MEMO

Department of Water Resources

Subject: Staff memorandum in response to expert reports submitted for Rangen Delivery Call (In the Matter of Distribution for Water to Water Right Nos. 36-02551 and 36-07694)

Figure 4. Measured water level in well 07S 14E 33 BBB1 and monthly average discharge at Rangen spring complex.

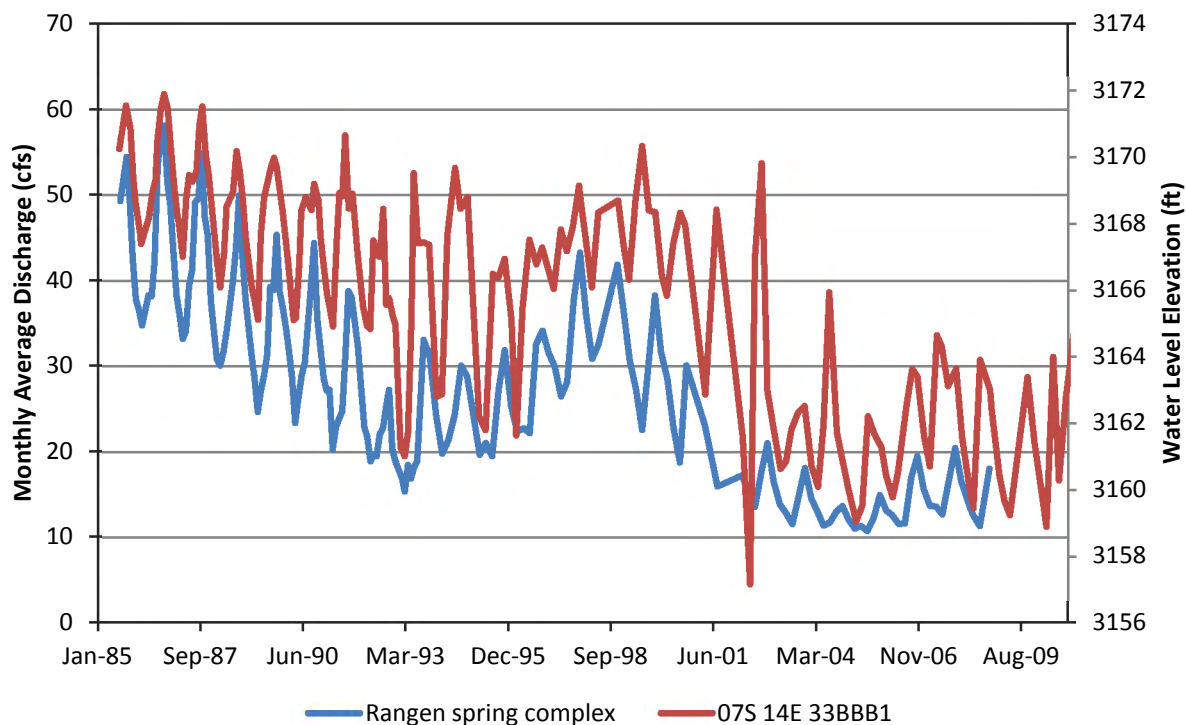
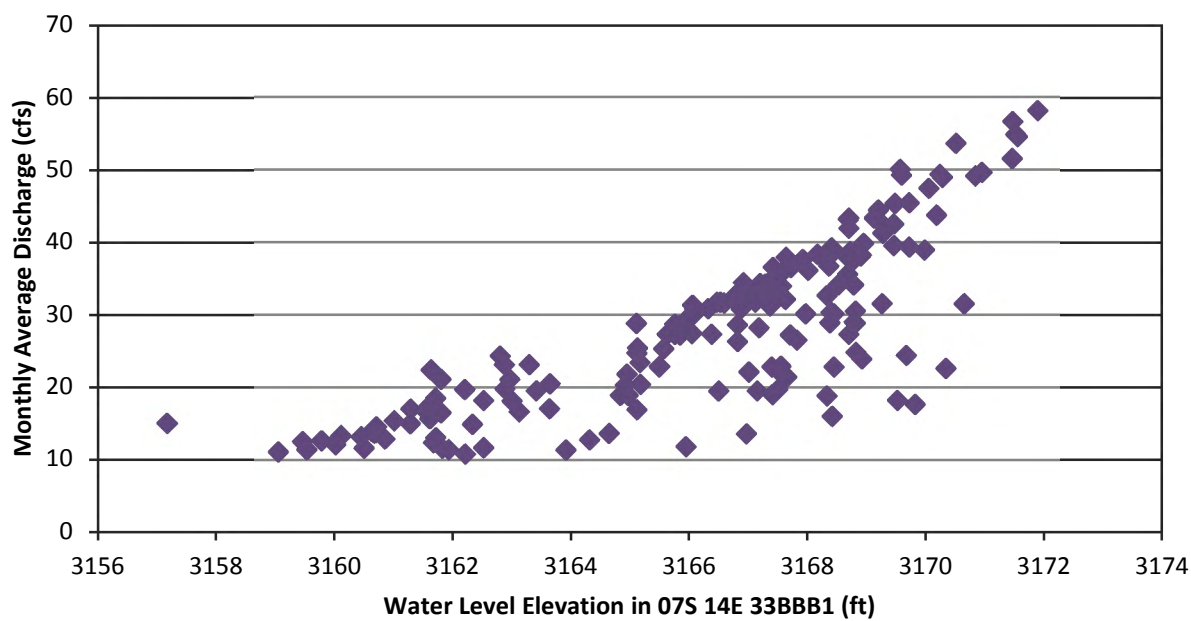
On page 27 and Figure 17, Hinckley (2012) presents the relationship between discharge of the Rangen spring complex and groundwater level measurements collected in a domestic well (07S 14E33 BBB1) located approximately one mile east-northeast of the Rangen spring complex. Water level measurements from this well were collected approximately bi-monthly by the USGS from 1985 to 2009, and by IDWR beginning in 2009. Mr. Hinckley asserts there is considerable uncertainty in the relationship between aquifer head and spring discharge. IDWR staff disagree, because Mr. Hinckley is not comparing spring discharge with aquifer head immediately adjacent to the spring complex his analysis ignores other factors, such as localized water level responses to nearby pumping wells or recharge sources, potential measurement error in both water level and spring discharge, and transient timing of responses to stress. Figure 4 shows a time-series graph of water level in well 07S 14E BBB1 and discharge at the Rangen spring complex. Figure 5 shows a graph of the relationship between measured water level and spring discharge. Note that much of the scatter discussed by Mr. Hinckley is associated with points in Figure 5 that appear to be outliers occurring when water levels above 3,166 feet were measured in mid-summer. These spikes in the water level measurements suggest that the well is responding to changes in nearby stresses. Changes in aquifer head immediately adjacent to the spring complex will be a function of the transient response time to these and other aquifer stresses.

Figure 6. Relationship between Current Tunnel discharge and water level in Rangen monitoring well, August 2008 to January 2012.

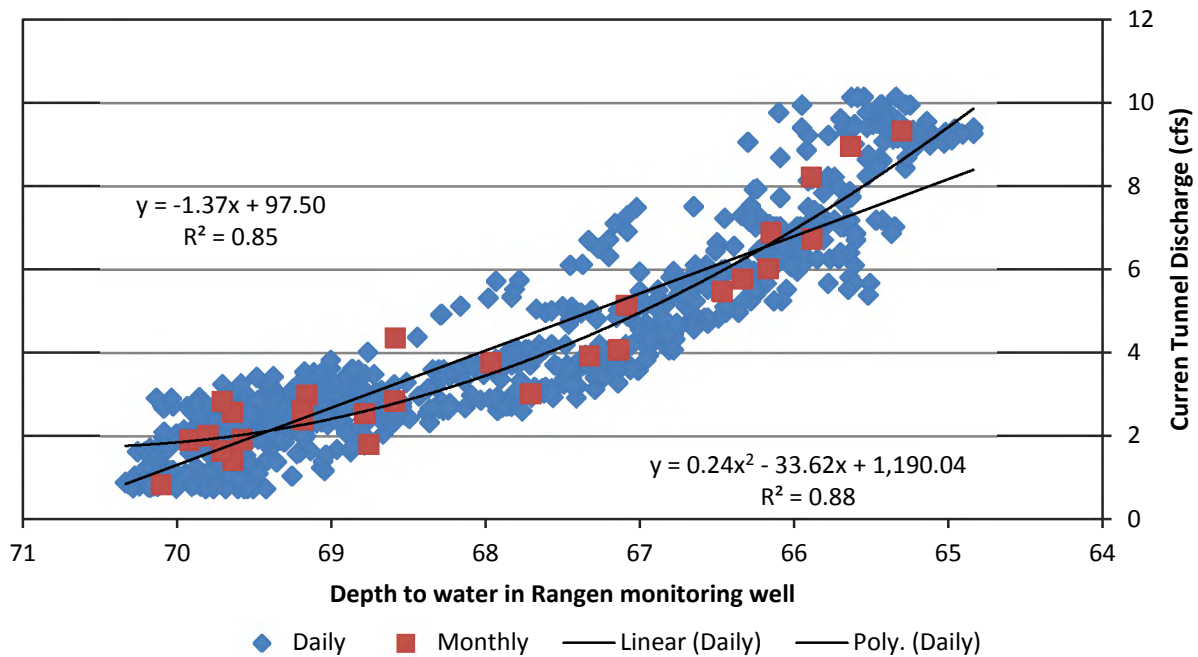
On page 28 and Figure 18, Hinckley (2012) presents the relationship between discharge of the Current Tunnel and groundwater level measurements collected in a monitoring well located approximately 600

feet east of the Rangen spring complex. The monitoring well was installed by the Idaho Water Resource Board (IWRB) in 2008, and daily water level measurements were collected by IDWR beginning in October 2009. In Figure 18, Mr. Hinkley compares daily measurements of water level and Curren Tunnel discharge. Mr. Hinkley asserts that this relationship indicates there is considerable uncertainty in the relationship between aquifer head and Curren Tunnel discharge, again ignoring potential measurement error and transient timing of spring responses to aquifer stresses. Further, linear regression of this relationship (Figure 6) indicates that 85% of the variability in the tunnel discharge during this 3-year period can be explained by a linear relationship with head in the monitoring well (Figure 5). Because the monitoring well was not installed until 2008, these data do not provide sufficient information to evaluate the response to water level changes that would be expected to occur if the aquifer water budget was changed by a model-wide curtailment of groundwater irrigation junior to 1962.

A more representative comparison of aquifer head and Rangen spring complex discharge would be comparison with IDWR Well No. 989, which is located approximately ½ mile northeast of the Rangen spring complex. This well is closer to the Rangen spring complex than well 07S 14E 33 BBB1 and has a longer record of water level measurements than the IWRB monitoring well. Well No. 989 has a record of 68 water level measurements collected between March 1998 and October 2008, representing a broader range of aquifer water budget conditions than the IWRB monitoring well. Well No. 989 was also used as a water level change calibration target in ESPAM2.1 (Figure 7). Comparison of measured water levels with spring discharge indicates that linear regression explains approximately 91% of the variability in the relationship between aquifer head at this location and discharge at the Rangen spring (Figure 8). These data indicate that there is a strong relationship between the change in discharge at the Rangen spring complex and change in aquifer head at the location of Well No. 989, with the discharge increasing by approximately 3.7 cfs per foot of increase in head.

Figure 9. Farmer (2009) conceptualization of potential groundwater flow from ESPA to Tertiary sediments and basalts.

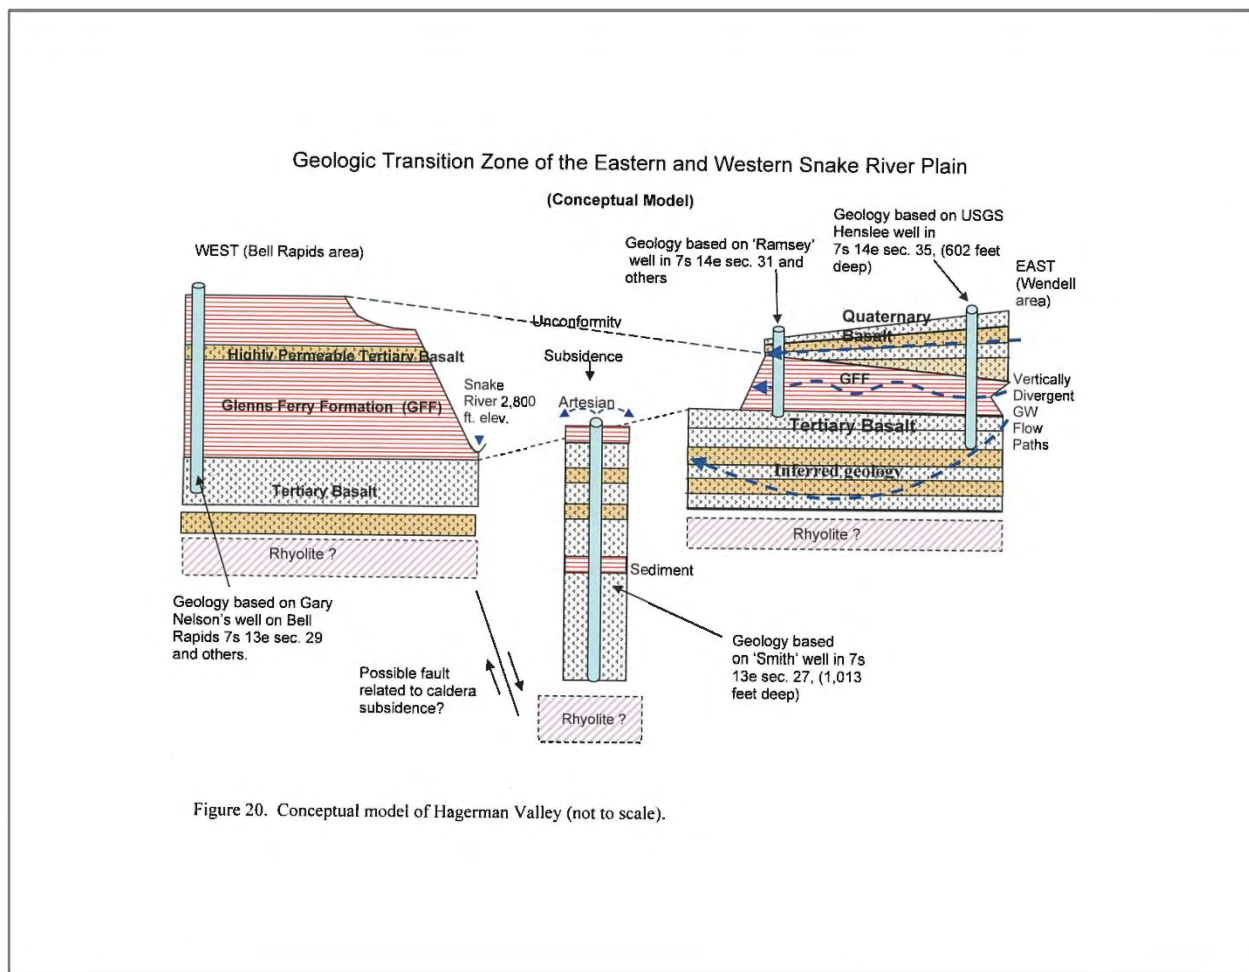
On page 42, Hinckley (2012) argues that the use of general head boundaries along the Hagerman rim effectively reverses the removal of the Hagerman Valley from the ESPAM2.1 model domain. IDWR staff disagree with this statement. The general head boundaries were added along the Hagerman rim to

allow discharge from the ESPA to Billingsley Creek and/or the Snake River via one of several pathways that may include talus flow that does not daylight as spring discharge, discharge from the ESPA to Tertiary sediments to Billingsley Creek, or discharge from the ESPA to Tertiary basalts to the Snake River as conceptualized by Farmer, 2009 (Figure 9). The general head boundaries were added to provide an outlet for ESPA discharge that reaches Billingsley Creek or the Snake River without surfacing as springs. This does not reverse the removal of the Hagerman Valley from the ESPAM2.1 model domain, because there is no modeled aquifer recharge or discharge occurring in the Hagerman Valley, and elevations of the general head boundary were selected to be low enough that there was not any flux modeled from the Snake River into the ESPA in the reaches below Milner.

The locations of general head boundaries used to model base flow below Milner were discussed by the ESHMC, including Dr. Brendecke on December 12, 2011 and the committee agreed that a general head boundary *“would be assigned to cells with springs that butt against the river, and for cells along the edge of the Hagerman Valley”* (Raymondi, 2011). IDWR staff note that the analyses submitted by Leonard Rice Engineers, Inc. with Rangen’s December 13, 2011 Petition for Delivery Call was performed using a preliminary calibration of ESPAM2 that pre-dated addition of the general head boundaries to the model. The results of their analysis (McGrane, et al., 2011) were similar to the results predicted by ESPAM2.1, suggesting that the addition of the general head boundaries along the Hagerman rim had little effect on model predictions of response at the Rangen spring complex.

Figure 12. Comparison of net ESPA recharge during model calibration period and simulation of curtailment to July 13, 1962.

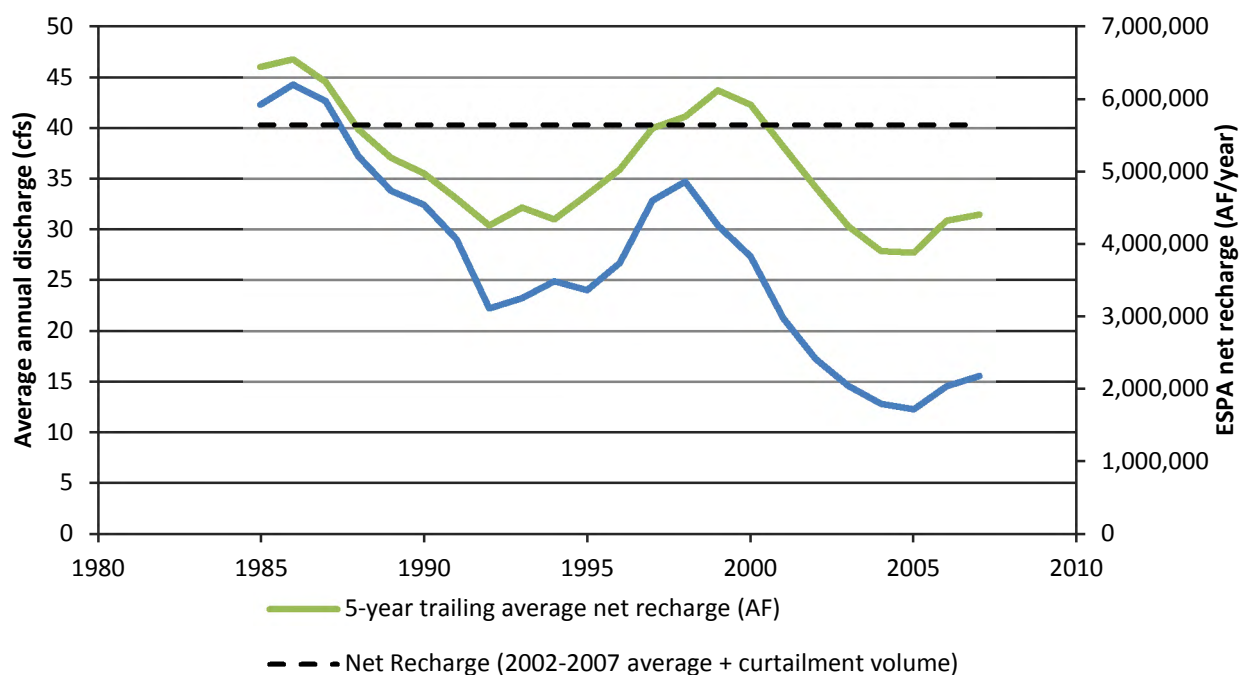
On page 4-14, Brendecke (2012) states that curtailment of large amounts of junior groundwater pumping would results in water use conditions “that are radically different from those extant in the model calibration period.” IDWR staff disagree with this statement. As shown in Figure 12, when the simulated curtailment volume is added to the 2002-2007 average annual net recharge, the net ESPA recharge is within the range of net recharge during the model calibration period and is closest to conditions that occurred in the late 1990s.

On page 4-3, Dr. Brendecke asserts, *“The curtailment scenario discussed by Rangen represents a ‘new distribution of stress’ as described by Reilly (1987).”* As shown previously in Figure 12, curtailment of groundwater use junior to 1962 would result in net ESPA recharge within the range that occurred during the model calibration period. Because the model is calibrated using net recharge, not the groundwater pumping portion of net recharge, the comparison made by Dr. Brendecke in Figure 4-1 is not relevant.

Figure 13. ESPAM2.1 transmissivity pilot points in the vicinity of the Buhl to Lower Salmon Falls reach.

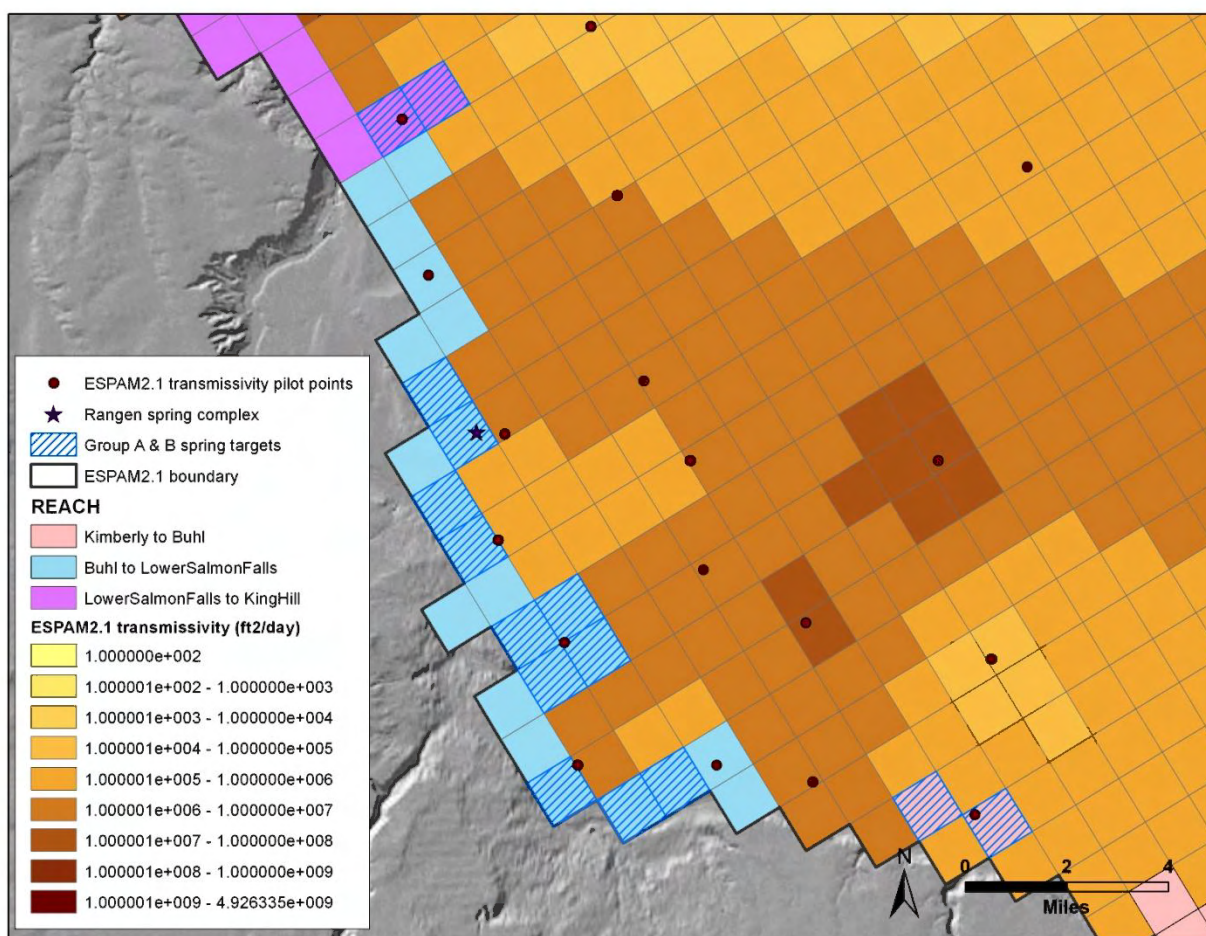
On pages 8 and 23, Contor (2012a) recommends that ESPAM2.1 not be used to predict responses at reaches smaller than the distances between nearby transmissivity pilot points. Figure 13 shows the ESPAM2.1 transmissivity pilot points in the vicinity of the Rangen spring cell and Buhl to Lower Salmon Falls reach. The Rangen spring cell is a one-square-mile model cell. The Buhl to Lower Salmon Falls reach is comprised of 24 model cells. The spacing between pilot points in the vicinity of the Buhl to Lower Salmon Falls reach is generally between two and four miles. If Mr. Contor's recommendation is applied, ESPAM2.1 would be used to predict the response at the Buhl to Lower Salmon Falls reach, because it is the smallest calibration reach that is greater than four miles in length.
